Access Compliance Report

(Curb Ramps)

Intersection ID: 52526	Main Street: MCCLINTOCK_RD	Cross Street: ANDREWS_LN	Location: SE
ADA ID: 7054FF016715	Ramp Type: Perp	Initial Pass/Fail: Fail	Overall Compliance: No
Severity Score: 10			
Codes/Mitigation Info/Possible Solution		Field Measurements/Component Compliance

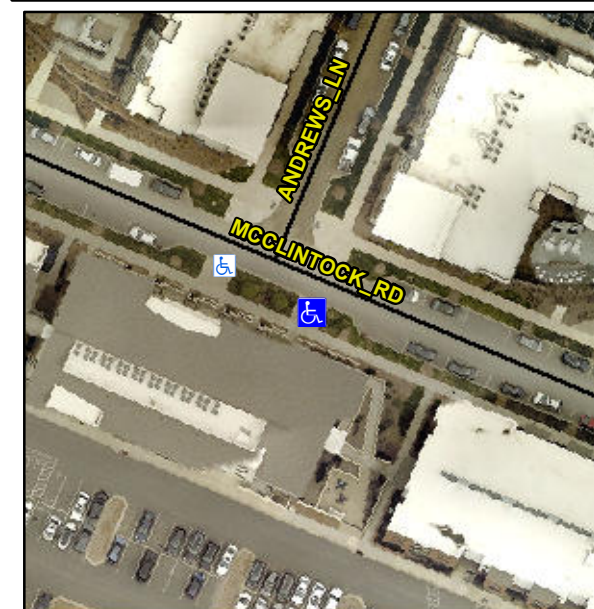
Compliance	Description	Data	Compliance	Description	Data
N/A	Ramp Length (in)	78.0	Yes	Ramp Slope (%)	6.5
No	Ramp Width (in)	47.5	Yes	Ramp XSlope (%)	3.5
N/A	Flare Type LT	N/A	N/A	Flare Type RT	N/A
N/A	Flare Slope LT (%)	N/A	N/A	Flare Slope RT (%)	N/A
N/A	Flare Traversable LT?	N/A	N/A	Flare Traversable RT?	N/A
N/A	Landing Length (in)	N/A	N/A	DWS Provided?	N/A
N/A	Landing Width (in)	N/A	N/A	DWS Contrast?	N/A
N/A	Landing Slope (%)	N/A	N/A	DWS Length (in)	N/A
N/A	Landing X Slope (%)	N/A	N/A	DWS Full Width?	N/A
N/A	Landing Curb? (Y/N)	N/A	N/A	DWS Offset (in)	N/A
N/A	Shared Landing?	N/A			
N/A	Gutter Ponding?	N/A	N/A	Gutter Slope (%)	N/A
N/A	Gutter Lip Ht (in)	N/A	N/A	Gutter X Slope (%)	N/A
N/A	Painted X Walk1?	No	N/A	Painted X Walk2?	N/A
	X Walk 1 Direction	To NE		X Walk 2 Direction	N/A
N/A	X Walk 1 Width (in)	N/A	N/A	X Walk 2 Width (in)	N/A
	X Walk 1 Slope (%)	2.1		X Walk 2 Slope (%)	N/A
	X Walk 1 X Slope (%)	4.2		X Walk 2 X Slope (%)	N/A

Remove & Replace Entire Ramp.

R304.5.1
